RAI Volume 2, Chapter 2.1.2, First Set, Number 1:

RAI Volume 2, Chapter 2.2.1.2, First Set, Number 2:

RAI Volume 2, Chapter 2.1.2, First Set, Number 3:

RAI Volume 2, Chapter 2.1.2, First Set, Number 4:

Figure 1. Classification of Repository Openings According to Accessibility

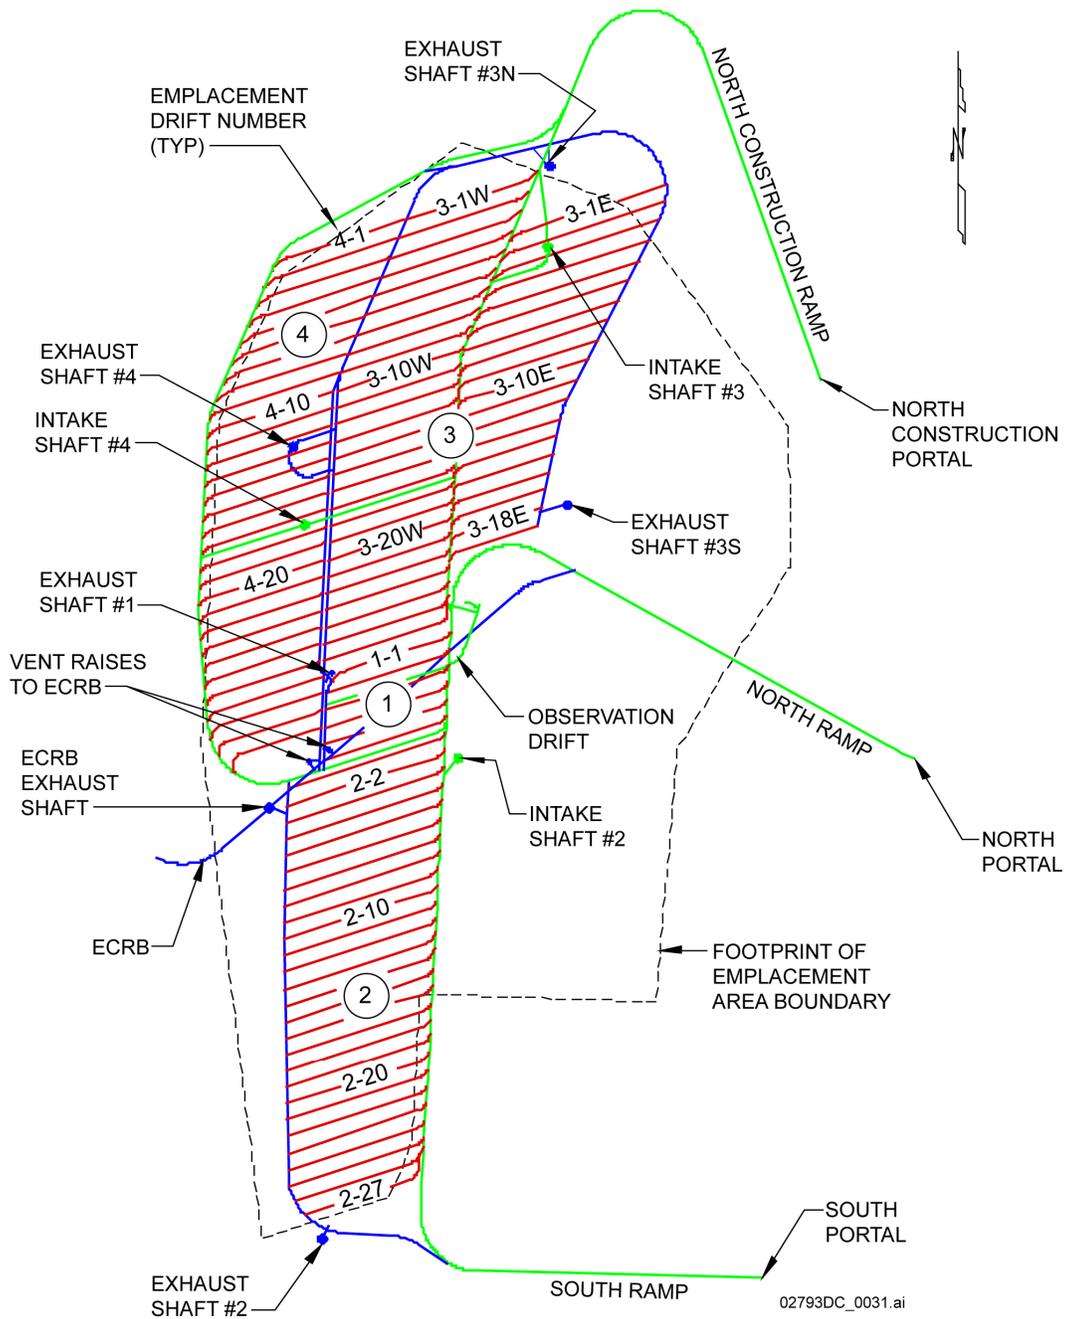
Provide a monitoring plan for the ground support system that explains what will be monitored, frequency of monitoring, criteria for selecting drifts to be monitored, spatial frequency of measurements within the drift, and the technical approach for processing information collected through monitoring to assess the performance of the ground support system and the need for maintenance to ensure access to waste packages through the preclosure period.

The SAR presents two distinct approaches for inspections, monitoring, and maintenance of repository ground support systems, depending on the classification of the repository openings for personnel accessibility as shown in Figure 1. These classifications are based on the expected thermal and radiation environments for the different openings. The specifics of the RAI are addressed separately for both accessible and inaccessible openings. Further differentiation is made in the response between those accessible and inaccessible openings directly used for a potential waste package retrieval operation and other repository openings not directly related to retrieval but still needed for support functions (i.e., ventilation). The monitoring and maintenance approaches for both types of openings are based on the robustness and the longevity of the materials selected for the type of opening. Monitoring and maintenance activities in inaccessible openings rely mostly on the use of remotely operated vehicles. Conceptual designs for two of these remotely operated vehicles are shown in Figures 2 and 3.

Figure 2. Framework and Wall Construction

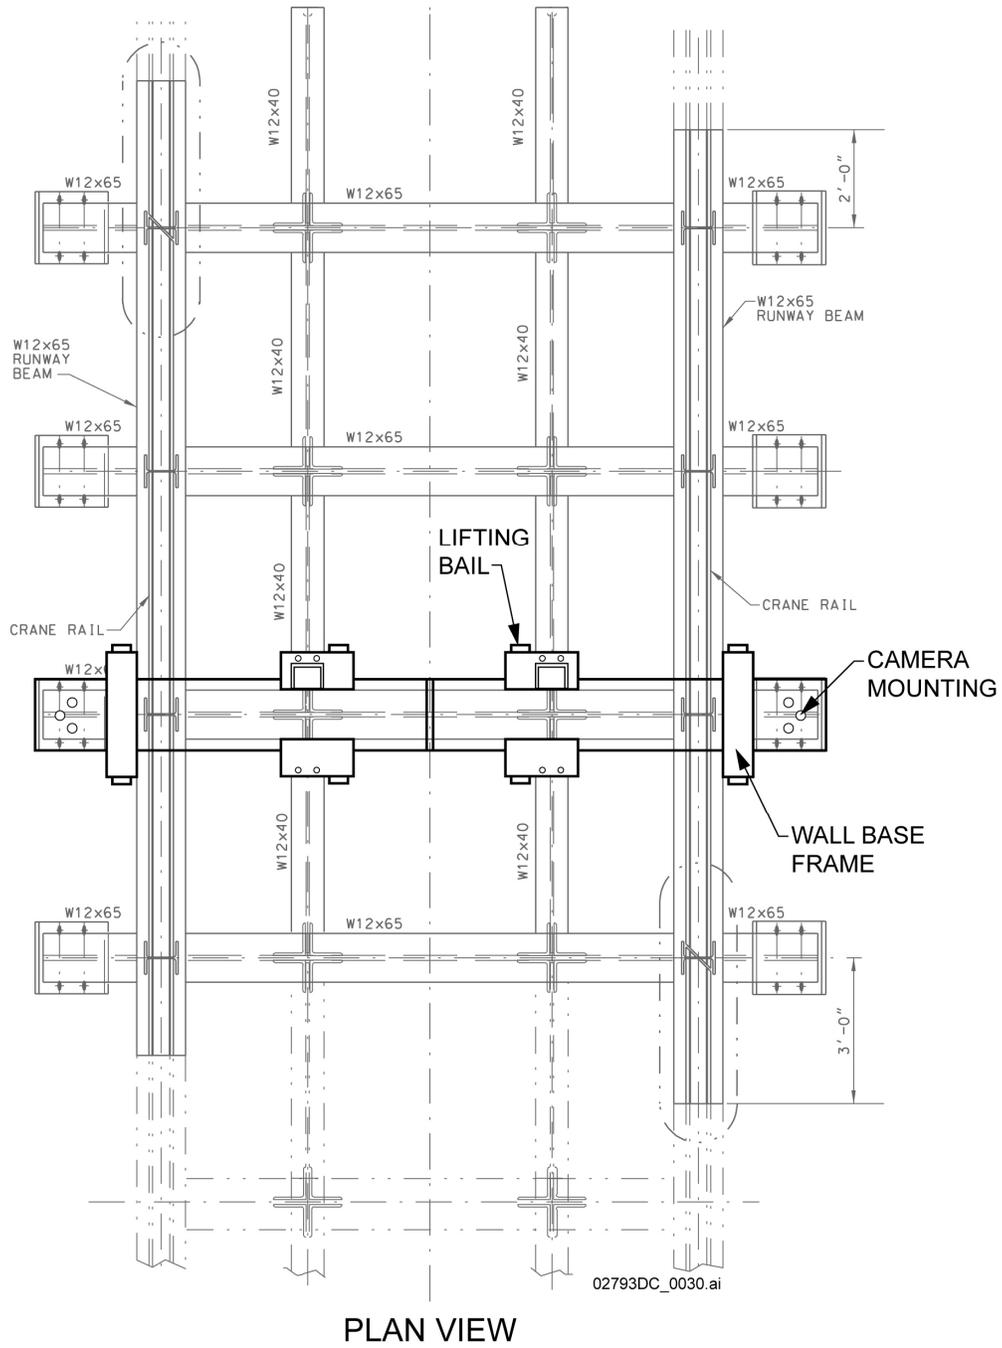
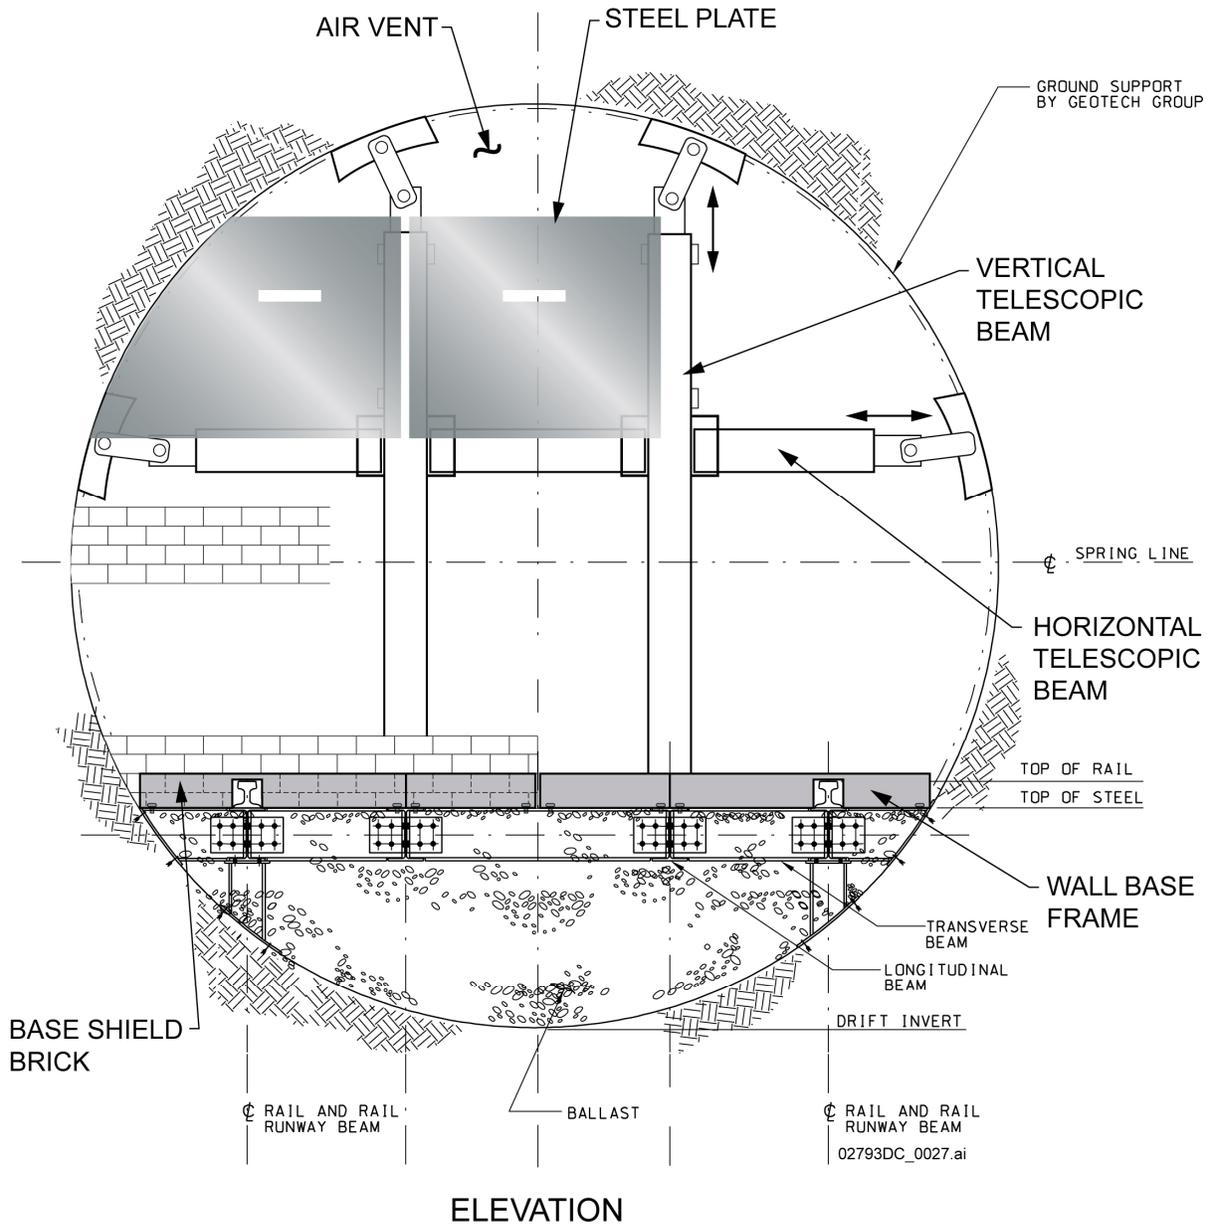
Describe how a temporary shield wall will be installed using the Multipurpose Recovery Vehicle (MRV). (Section 3.3.4 of BSC 2007b).

The wall base frame would be secured to the transverse and longitudinal beam using the torque wrench while being monitored via the cameras. The wall base frame is shown in Figure 2. These steps would be repeated for the installation of the second half of the wall base frame. Once installation of the wall base frame has been completed, the MRV would be readied for the next operation.

The vertical beam framework would be built by using two vertical telescopic beams, one center horizontal beam, and two side telescopic horizontal beams, as shown in Figure 2. The beam extension would be achieved by using a load-lifting screw jack with screw actuators mounted on the beam and operated by a torque wrench held by the MRV manipulator arm.

Figure 1. Rock Rubble Volume of 6.25 m³/m with Waste Package Emplaced

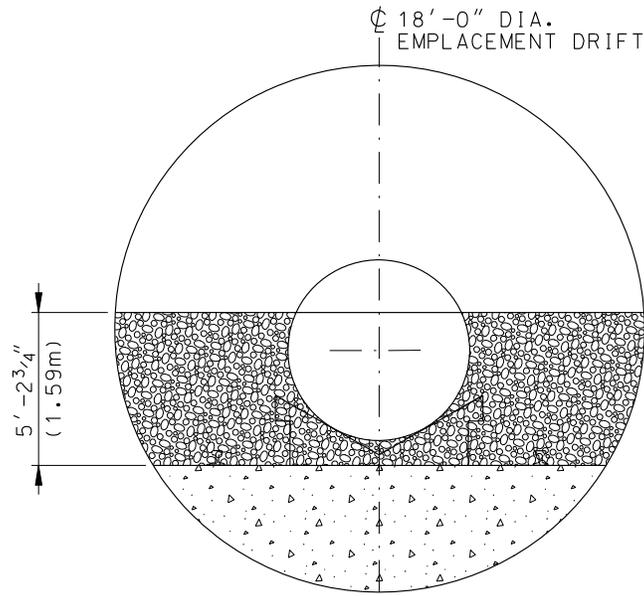
Provide information to a) define limits to waste-package temperature or physical damage that would not impair retrieval and to b) determine if off-normal conditions such as invert failure or rubble blockage of a ventilation conduit could cause the limits to be exceeded.

For the more conservative waste package burial configuration illustrated in Figure 1, analyses performed with ANSYS for a drift air temperature of 100°C , based on a $6.25 \text{ m}^3/\text{m}$ rockfall confined to the excavated emplacement drift diameter and resulting in a waste package burial height of 80%, demonstrate that a maximum OCB surface temperature of 451°C is reached. This estimated peak temperature is less than the 501°C and the 538°C limits that prevent creep rupture of the weldment material and loss of the Alloy-22 structural properties, respectively. The maximum temperature of the OCB is estimated to occur at the bottom of the waste package (BSC 2008, Section 7.2), with other portions of the OCB experiencing lower temperatures due to closer proximity to the free surface of the rubble. The OCB surface temperatures at the side (mid-point) and top of the waste package are estimated as 364°C and 180°C , respectively (BSC 2008, Figure 13).
